Pollard Street

Section 73 Addendum to Accompany
Design and Access Statement

December 2023

Hawkins\Brown

Typical Upper Floor Plan

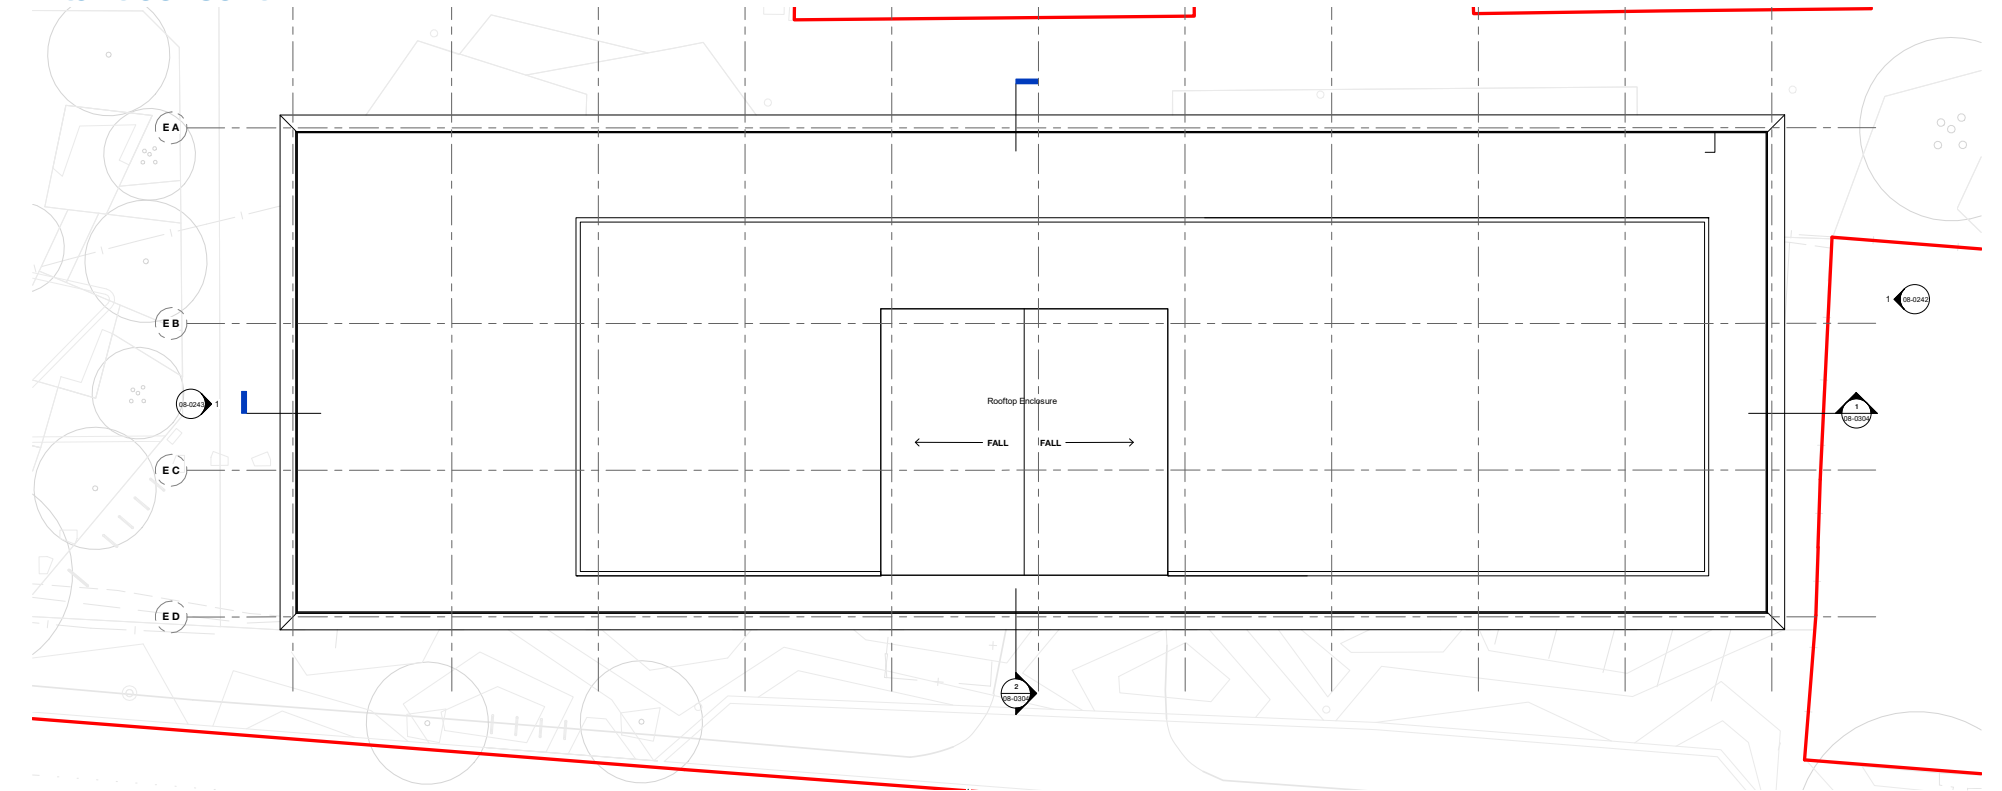
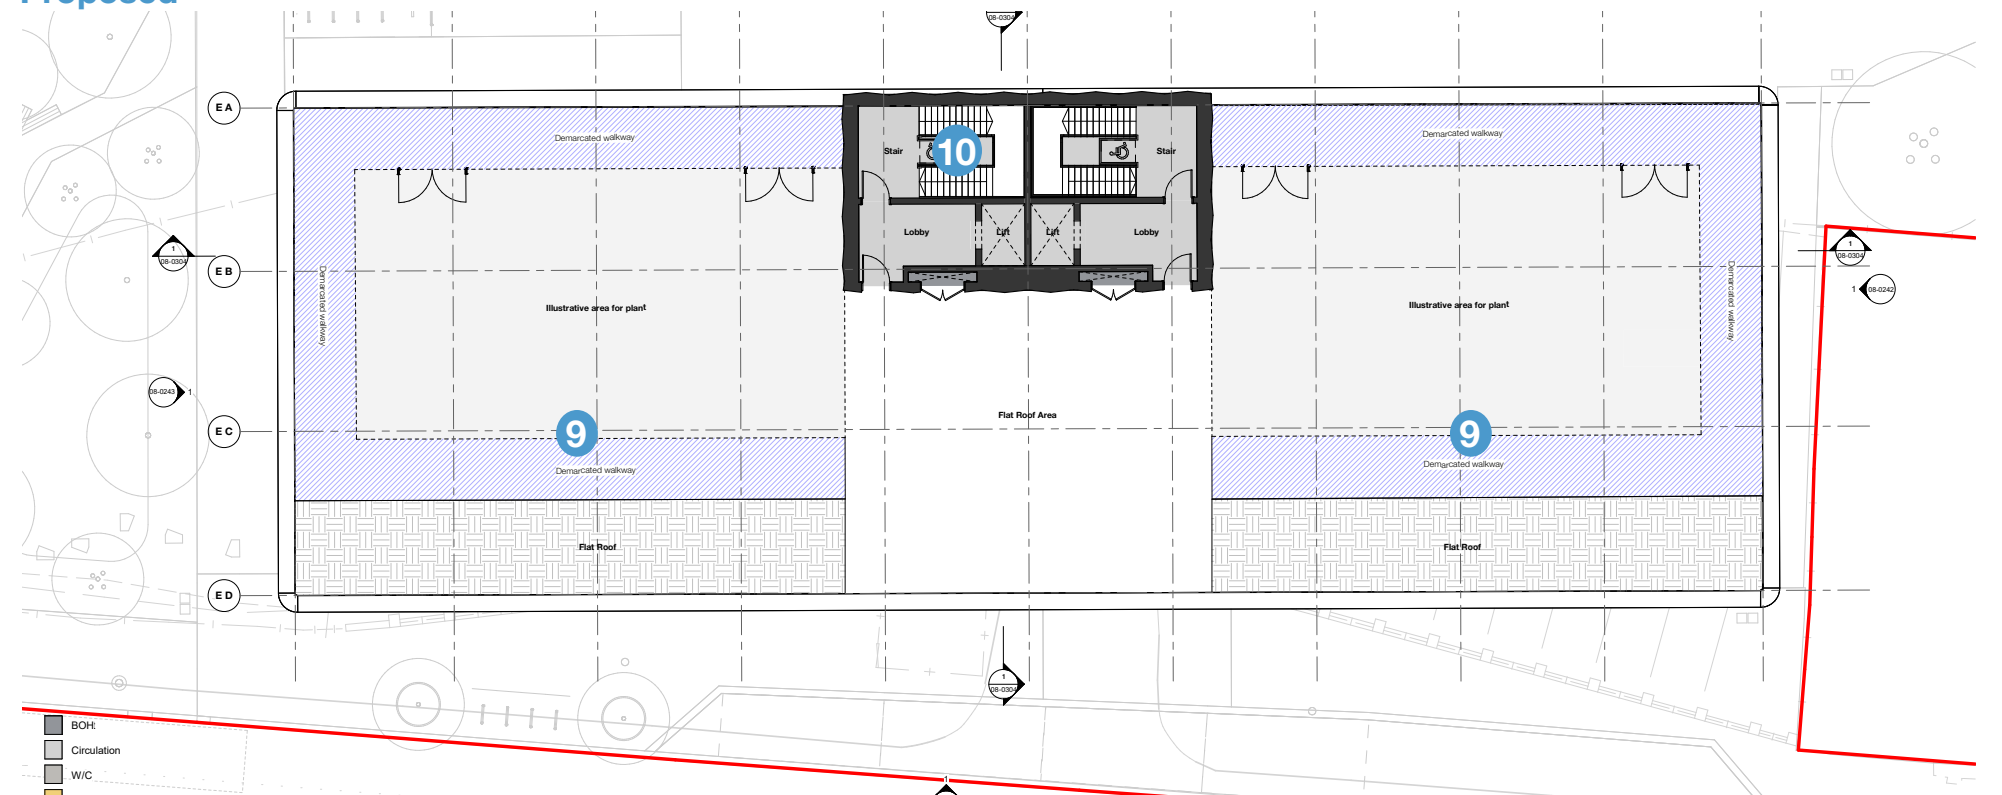
1. Primary façade cladding changed from metalwork to brickwork
2. Window arrangement updated
3. Main workspace entrance relocated
4. Ground floor access relocated
5. Second stair relocated within the central core
6. Internal layout updated
7. External gantry replaced with external terrace
8. Roof terrace relocated
9. Position of plant screen updated
10. Roof access updated

Materiality - planting

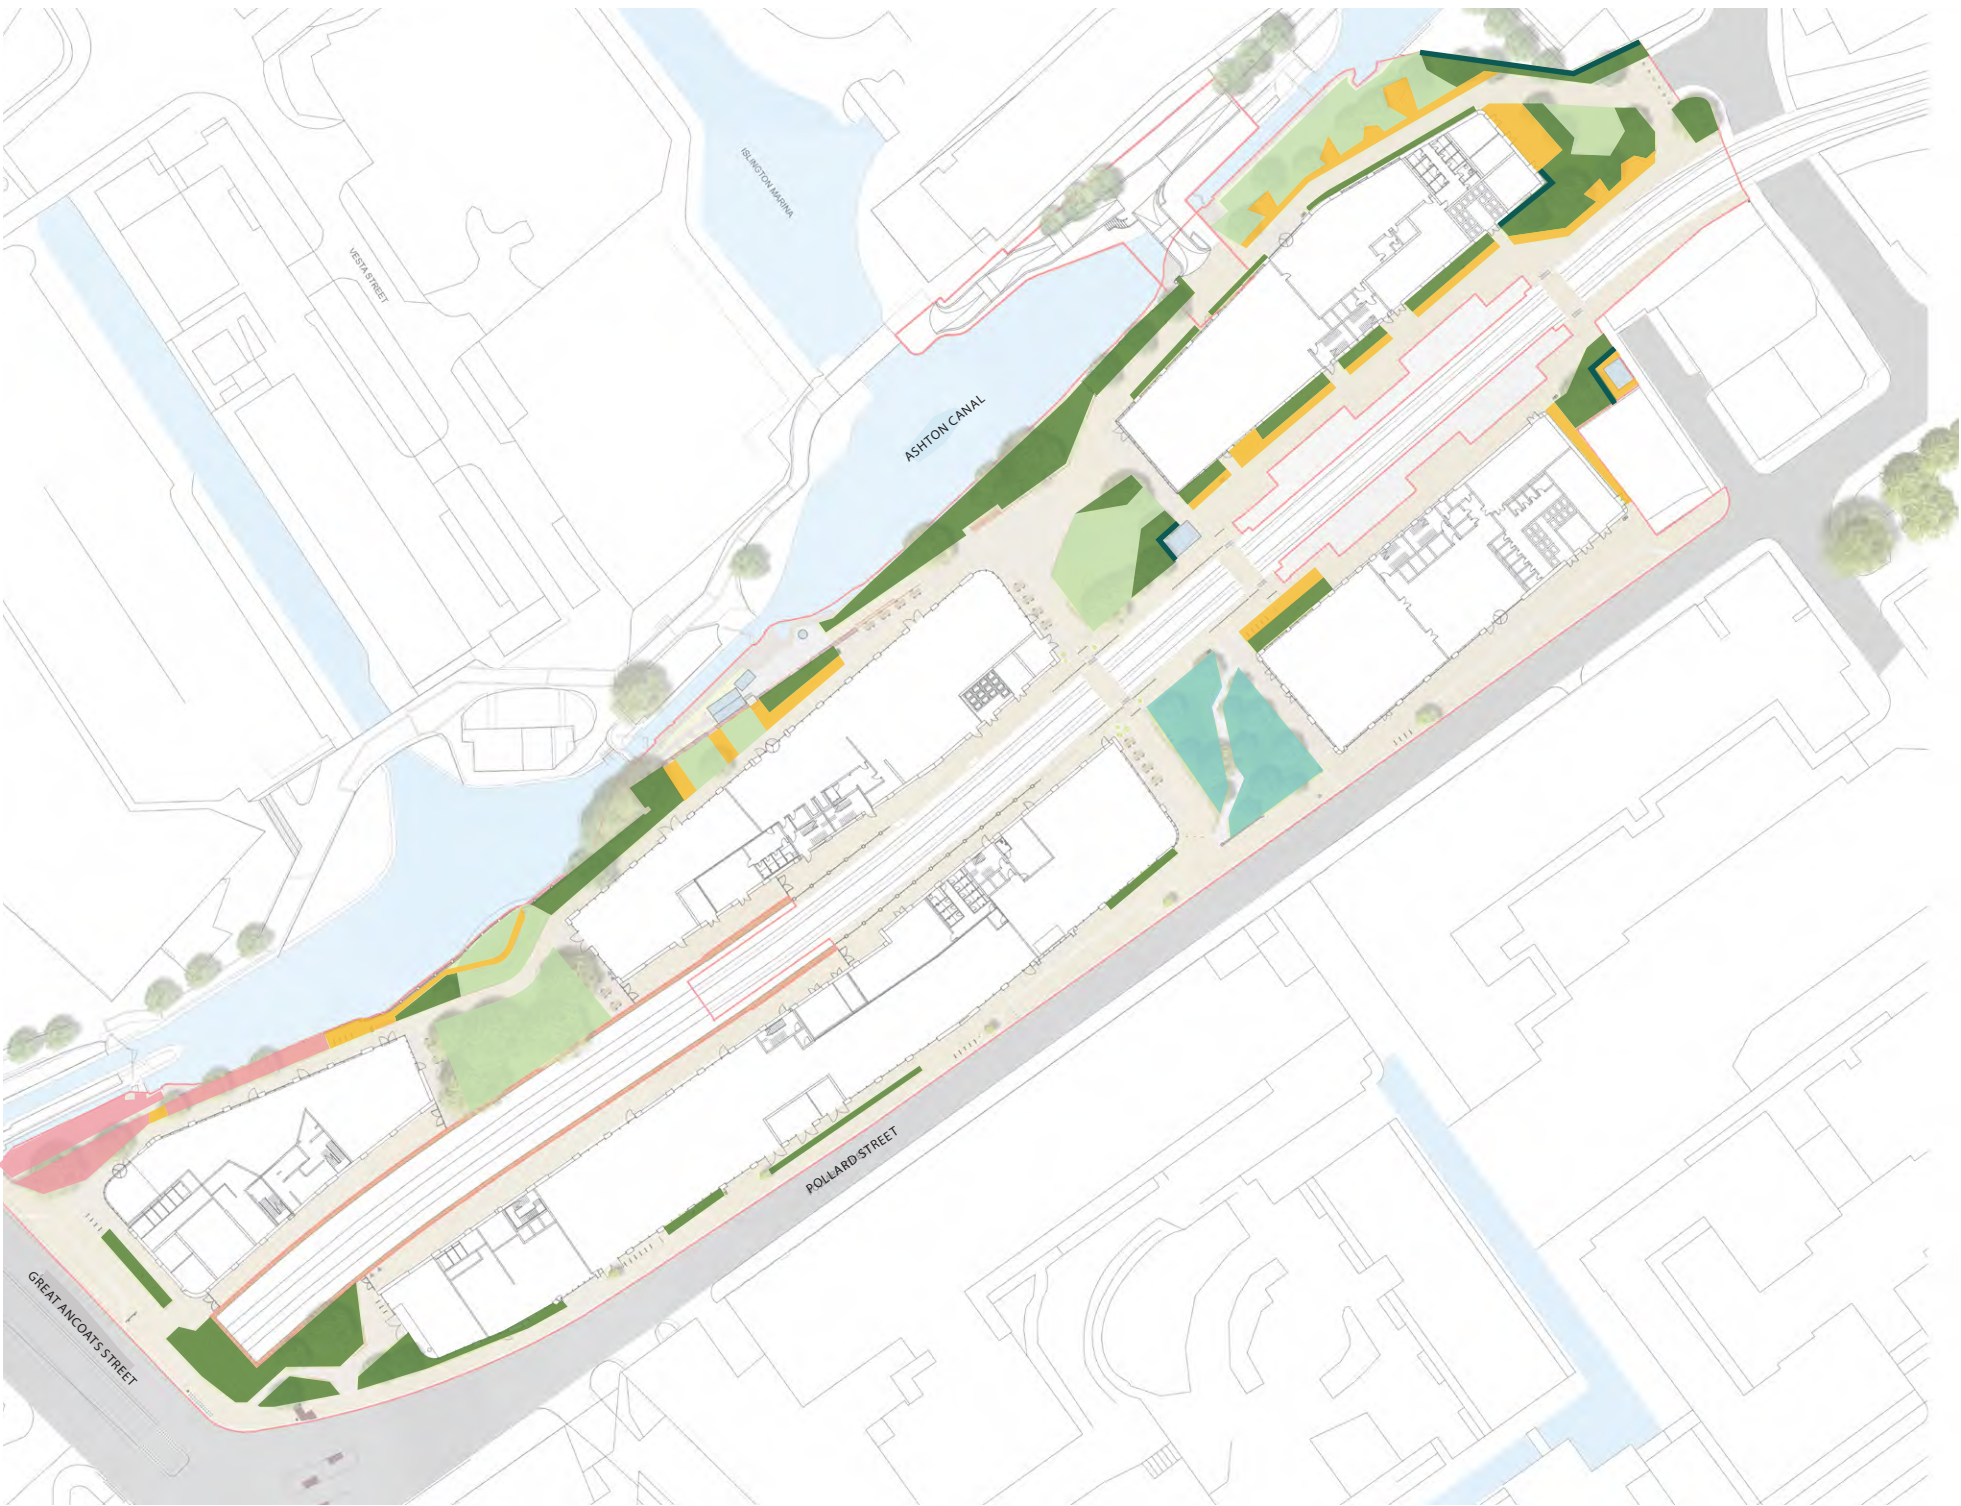
Following further design development, it has become clear that we are unable to plant trees in the ground along Pollard Street. Instead, these trees are proposed in large planters and will be equipped with water reservoirs for periods of warm weather.
